Wisconsin Department of Transportation

Proposal #14: 1060-34-73
Zoo IC, DPW Site Facilities
Milwaukee Co DPW Site
USH 45
Milwaukee County

This is Addendum No. 2, which provides for the following:

ADDENDUM NO. 2

Addendum No. 2
ID 1060-34-73
Revised Sheet 5
March 3, 2015

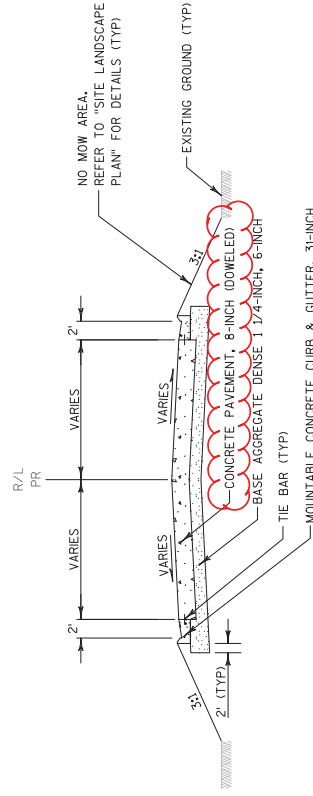
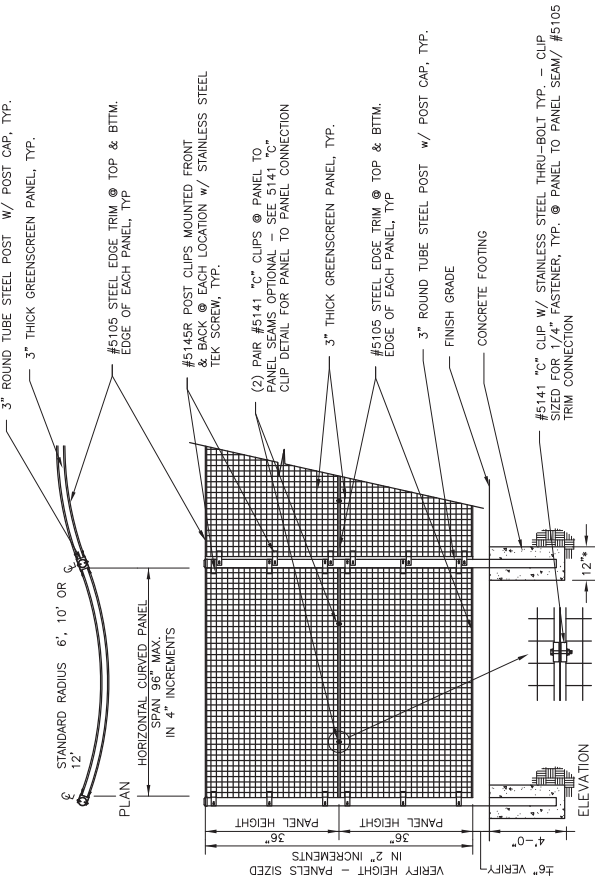
Revised Plan Sheets	
Plan Sheet	Plan Sheet Title (brief description of changes to sheet)
5	Typical Sections (Concrete pavement shall be doweled)
6	Typical Sections (Concrete pavement shall be doweled)
69	Site Landscape Details (Gabion baskets shall be 9 gauge steel)
158	Building Plan Typical Masonry Sections and Details (#4 stirrups @ 8" OC for Storage Bldg 1)
